Plan No. SP 63 00 Date/Time: 06/16/00 12:34pm
 Project Name: United States Parcel Service - Monticello Branch
 Rough Location: Monticello Ave Ext., 2000' East Intx. of M.A.E. + V3199
 ADC Map: Sheet 5 Grid: H - 8 First Review
 Flood Map / Zone: 510201- 00 35B Zone: X Review 08/28/00 9:00am
 Description: outside 500-year Floodplain
 Drainage Area: Onsite Only Offsite Only Combination of Both

Re: Monticello Post Office
Monticello Avenue
Williamsburg, Virginia
TAF Job No. 90672D

Addendum to Design Calculations and Design Narrative to Support Downstream Check Dam Structures

ENVIRONMENTAL DIVISION REVIEW COMMENTS
MONTICELLO BRANCH POST OFFICE
PLAN NO. SP - 63 - 00
October 5, 2000

CHECKDAM MAINTENANCE SCHEDULE

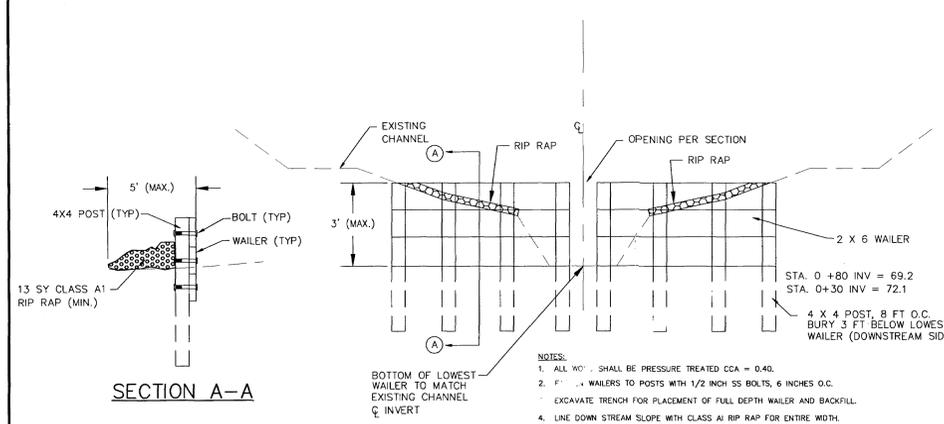
- ✓ 8. Maintenance Schedule. Address sediment removal requirements behind the check dams in the maintenance schedule on Sheet ENV1.00. See Minimum Standard & Specification 3.13 of the Virginia Stormwater Management Handbook (Page 3.13-14).

Our Corps permit will allow us to impact the wetlands in the area of the footprint of the structure. These are the only areas permitted for disturbance and mitigated for at a ratio of 2:1. Our Corps Wetland permit will not allow us to remove sediment behind the check dams as this would disturb additional wetlands. As a result, we only plan to call for removal of brush and debris from behind the check dam as part of the maintenance for this structure. We trust that this will meet the requirements of James City County.

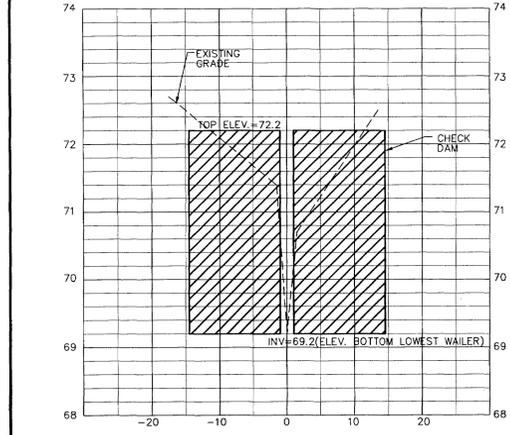
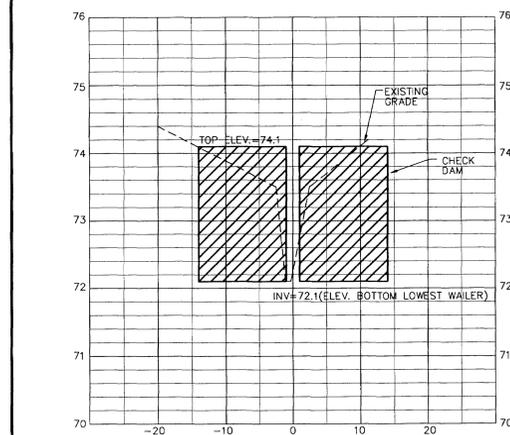
- ✓ 4. Backwater Pool Impacts. Based on Section 0+30 on Sheet ENV1.00, the proposed top of check dam elevation appears to be at El. 74.1 ±. Larger storm event pooling to this elevation could impact and create an unanticipated tailwater condition at the outlet end of the 48 inch diameter VDOT culvert across Monticello Avenue (invert out 72.95). Provide further information to show a tailwater depth of 1.15 feet will not have an adverse impact on the design and function of this road cross-culvert. (*Note: VDOT review and approval may be necessary due to this situation*).

- ✓ 5. Check Dams. Clearly show the proposed top of check dam elevations on Section 0+30 and 0+80 on Sheet ENV1.00.
- ✓ 6. Check Dams. Indicate a invert elevation match point between the typical check dam detail, Section A-A and Section 0+30 and 0+80 on Sheet ENV1.00. It appears the check dam invert elevations as shown on Section 0+30 and 0+80 would match the lowest 2 x 6 wailer (wale) bottom and not bottom of the 4 x 4 posts.

- NOTES:**
1. TOP LENGTH OF TOTAL CHECK DAM = 29 FT.
 2. OPENING WIDTH = 2 FT, OPENING HEIGHT = 3 FT.

- NOTES:**
1. TOP LENGTH OF TOTAL CHECK DAM = 28 FT.
 2. OPENING WIDTH = 2 FT, OPENING HEIGHT = 2 FT.

> 4. We propose eliminating the first check dam.
> 5. We will comply.
> 6. We will review.
> 7. We will provide a calculation.
> 8. We advise against the sediment removal. This is not an E&S device
and
> these are wetlands. We wish to minimize impacts here to the natural
> state.
> The stream will again seek its own stabilized flow patterns and this
will
> not be necessary.
>
> Please respond to the above for clarification and we will revise the
> documents as necessary. As a general comment, we feel that this is a
> low-tech device and do not wish to complicate the design too much.
>
> > -----Original Message-----
> > From: scottt@james-city.va.us [SMTP:scottt@james-city.va.us]
> > Sent: Friday, October 06, 2000 9:36 AM
> > To: swsmith@tafgroup.com
> > Cc: schmidle@james-city.va.us; decook@james-city.va.us;
> > jtphorne@james-city.va.us
> > Subject: JCC Env Div Comm SP-63-00
> >
> > Scott W. Smith, PE
> > The TAF Group

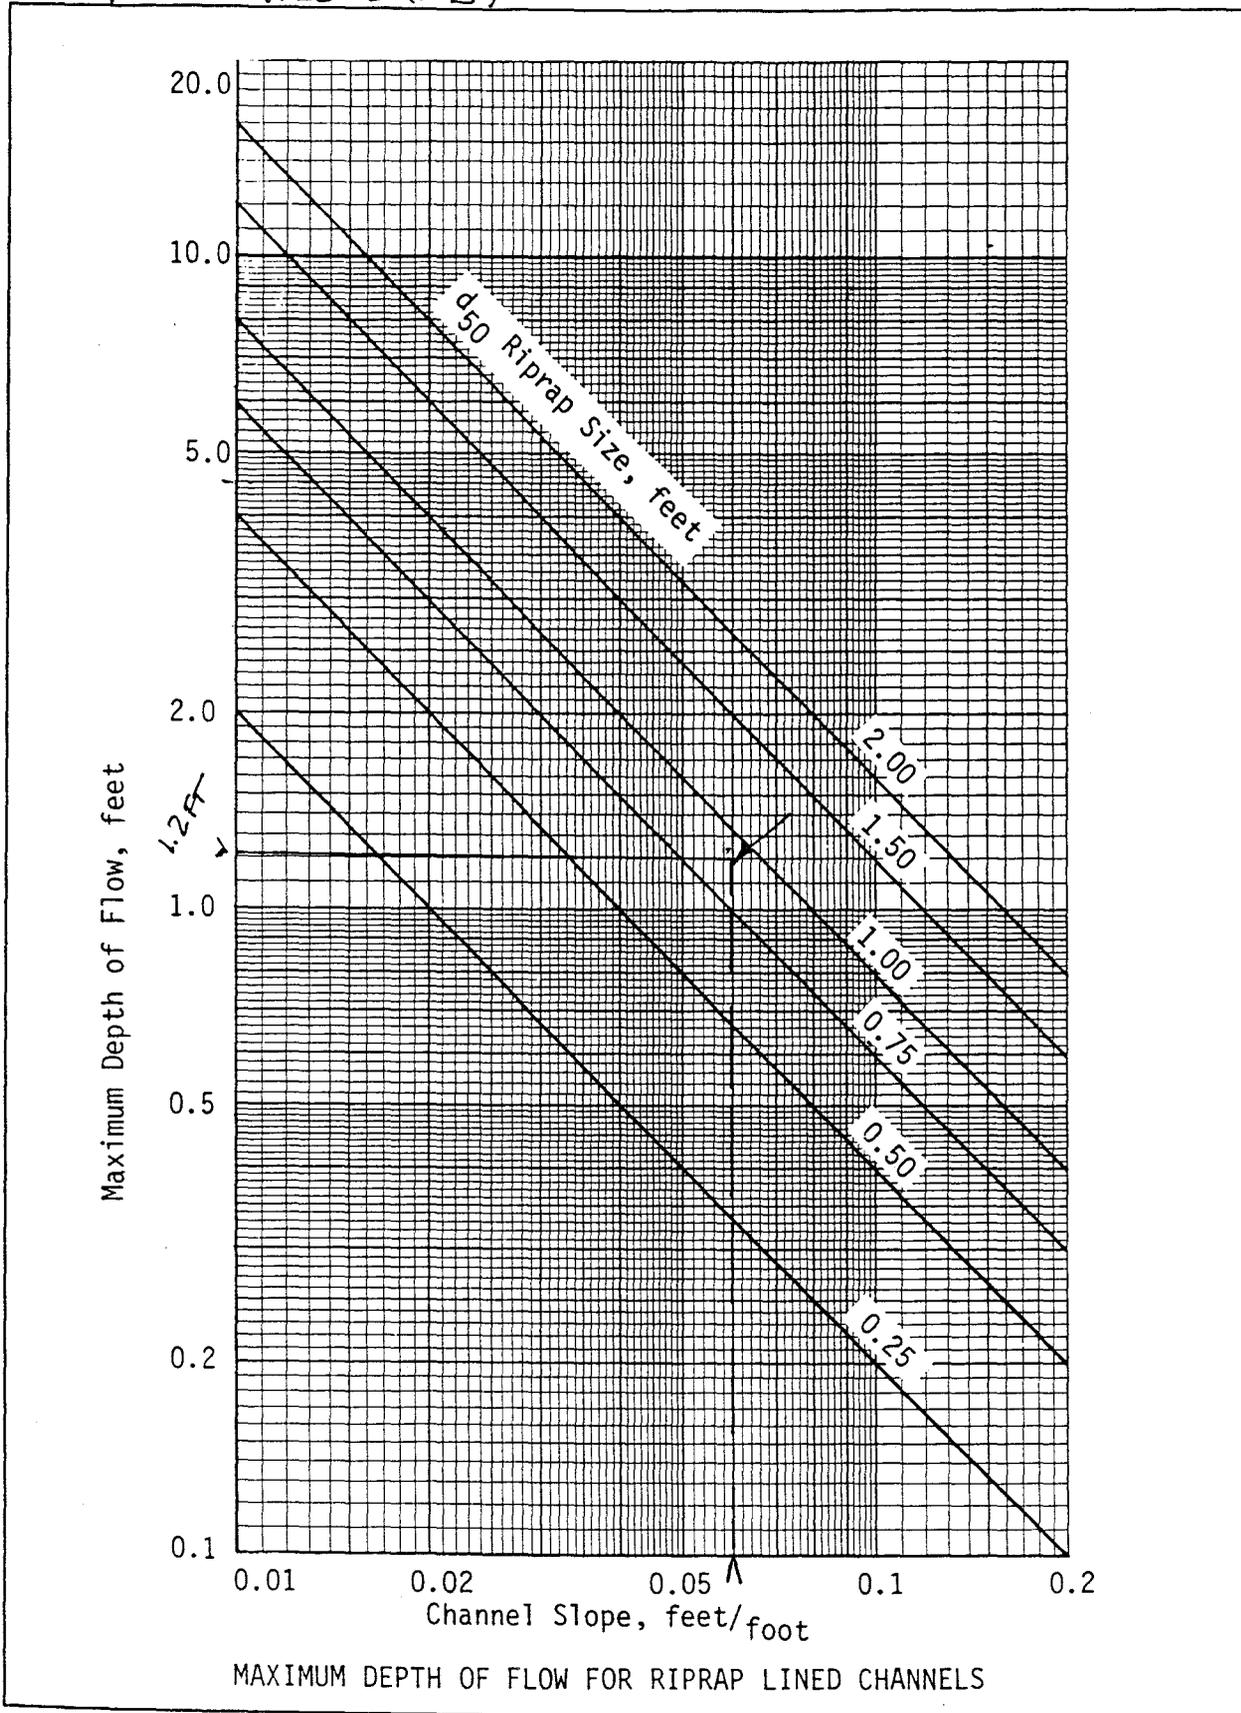
- ✓ 7. Toe Protection. Provide evidence to support use of Class A1 riprap as toe protection downstream of the timber check dams. If weir flow occurs over the top of the check dams, ensure the riprap will not wash downstream.

At the request of James City County, we provide the following analysis of the stability of the Class A1 riprap downstream of the check dams.

- Riprap located only in over-bank area and not main channel section.
- Primary velocity and shear stress associated with flow through check dams will occur in the main channel and not in over-bank areas.
- Design to 10-Year event.
- $Q_{10} = 50$ CFS (from drainage calculations).
- Maximum Depth of flow in over-bank areas is one foot by inspection of the typical check dam detail.
- Channel Slope is 0.06 ft/ft (from plan ENV 1.00).
- VDOT Class A1 rip rap: $D_{15} = 0.7$ ft, $D_{50} = 0.90$ ft.

Therefore, from VESCH plate 5-31, riprap is ok for given flow conditions up to depth of 1.2 ft (see attached).

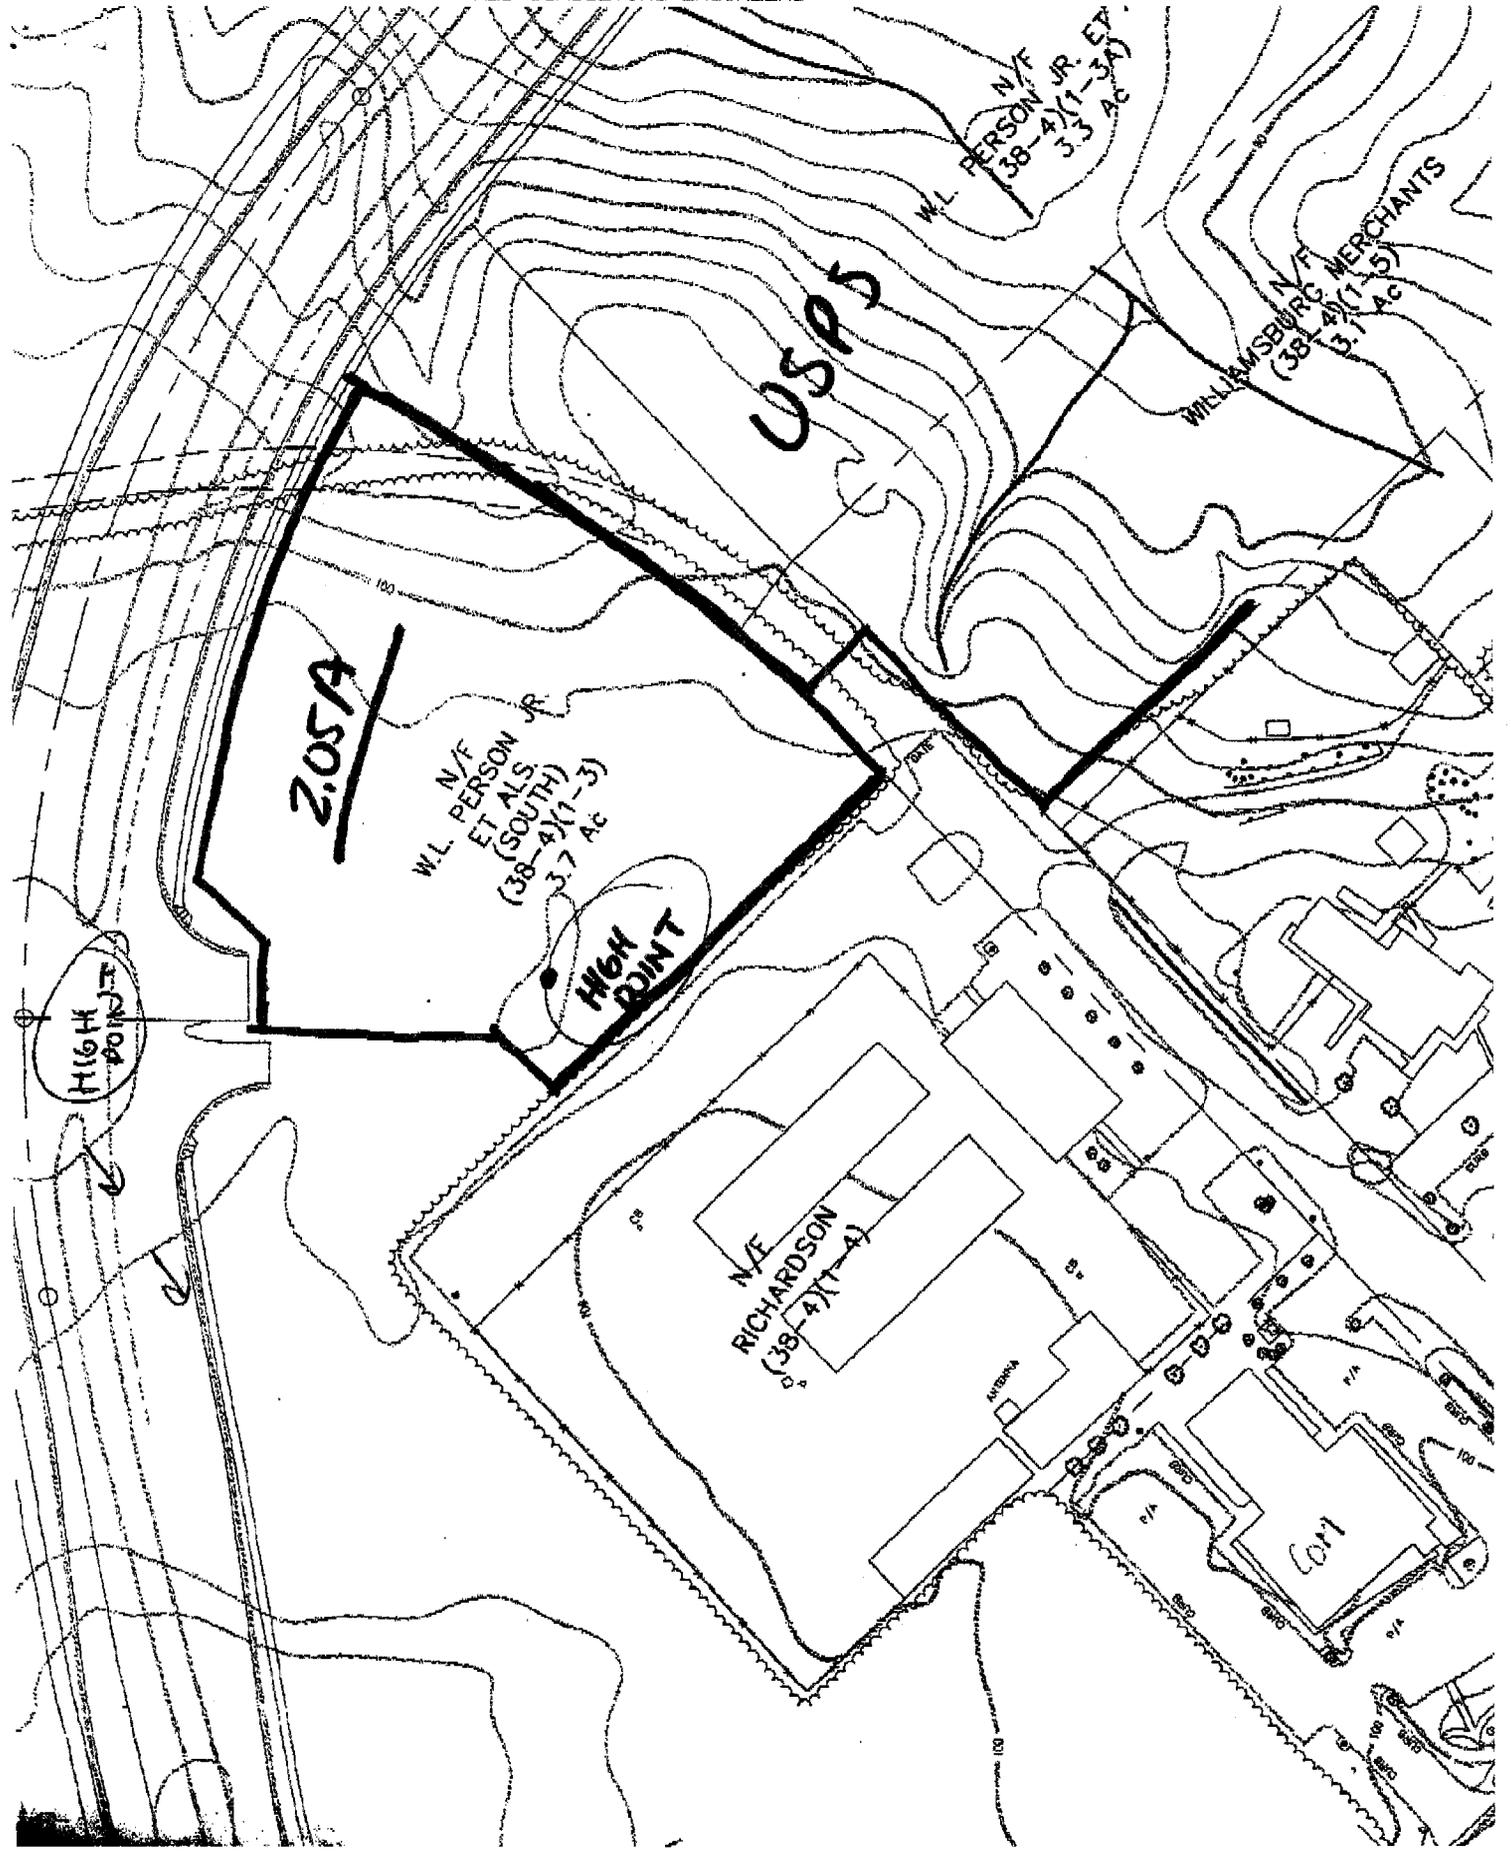
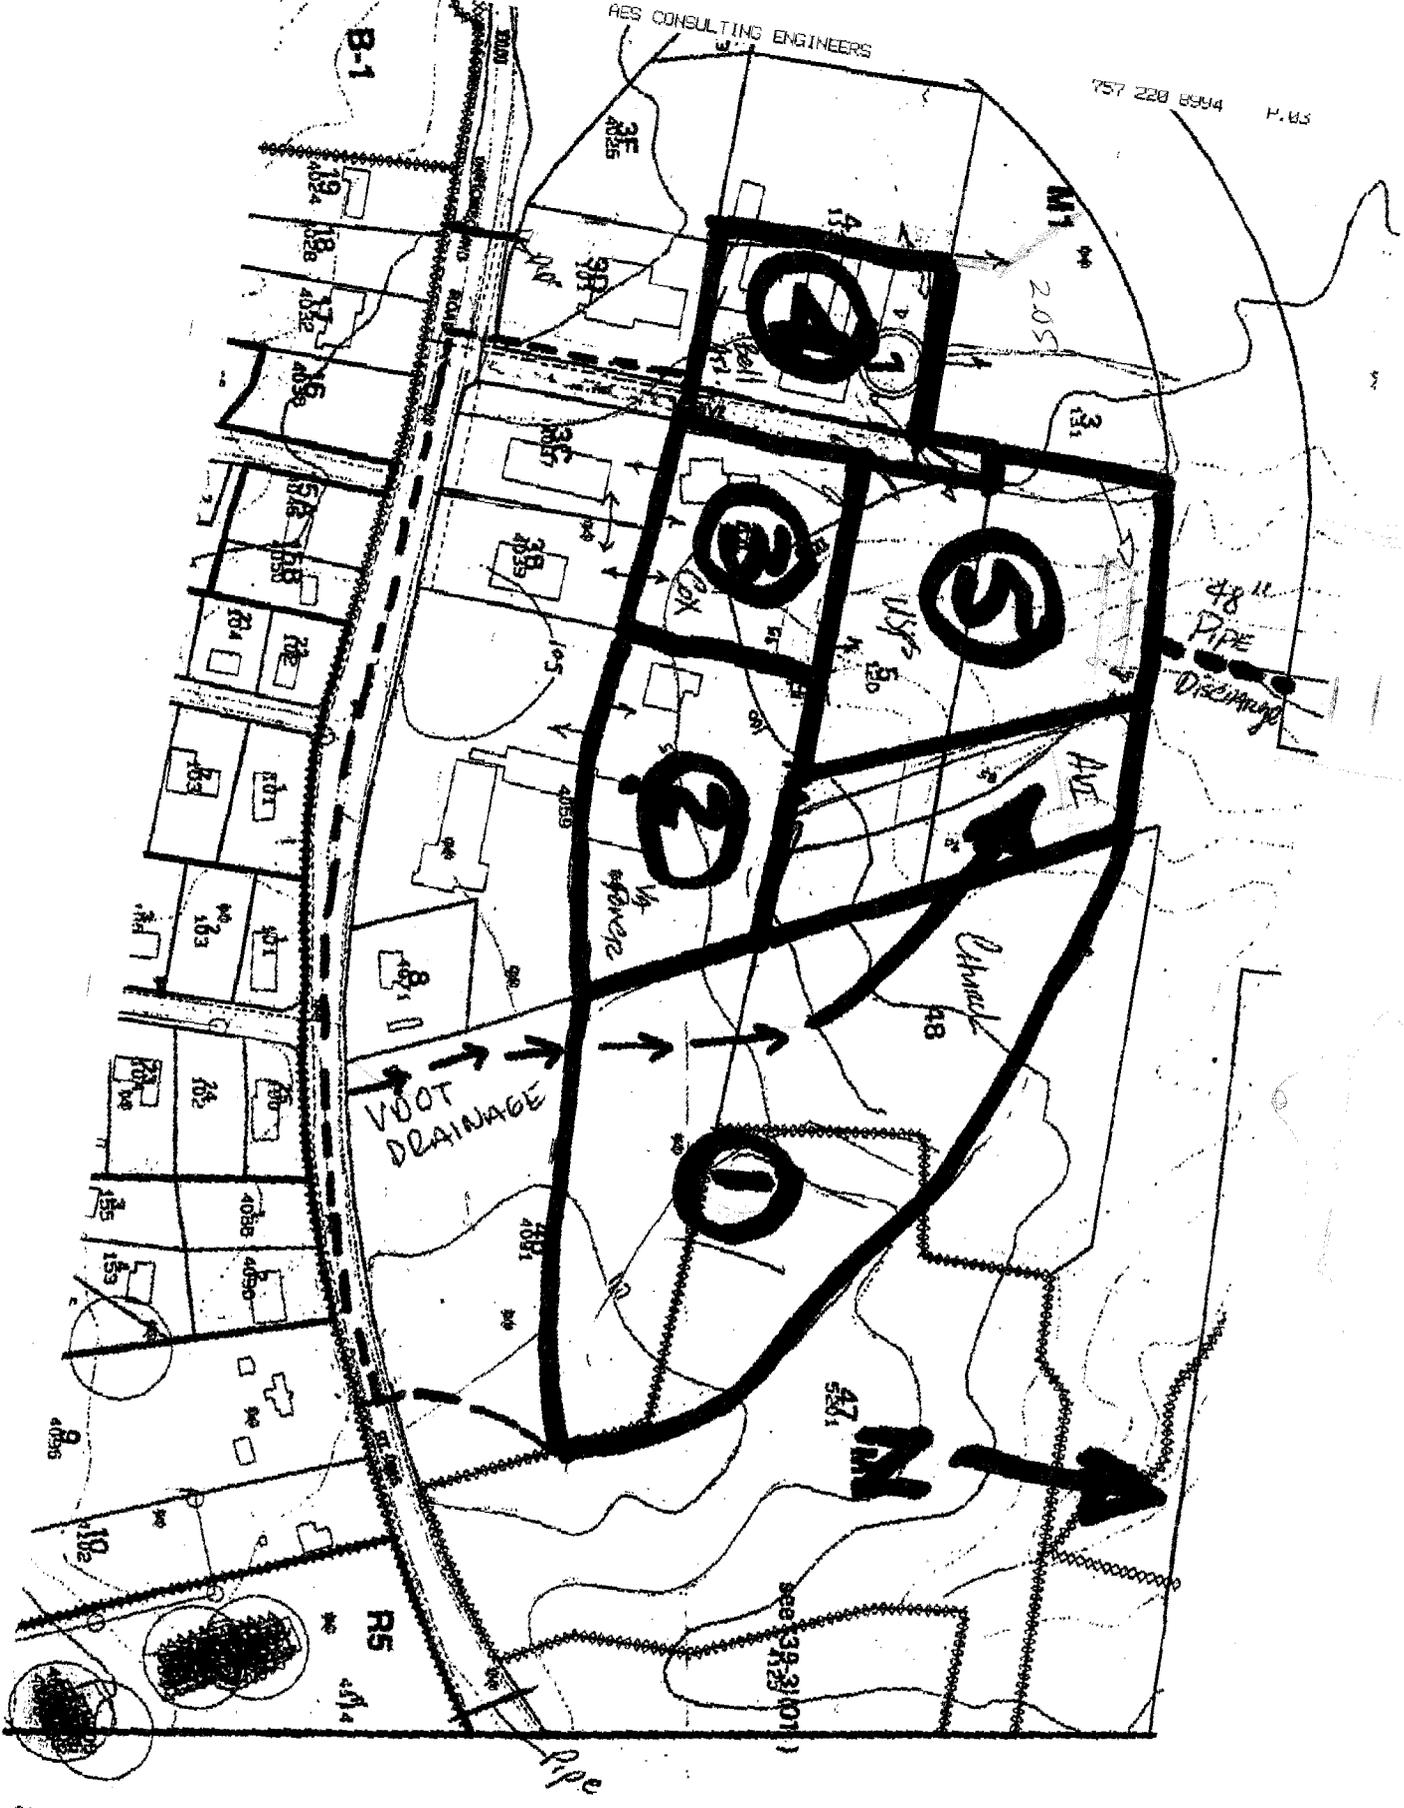
2. I have marked up your drawing based upon our field info and more detailed topo showing the area of UDOT drainage from Ironbound Road. Lot 30 was rerouted across the road years ago otherwise it would also go to the 48"
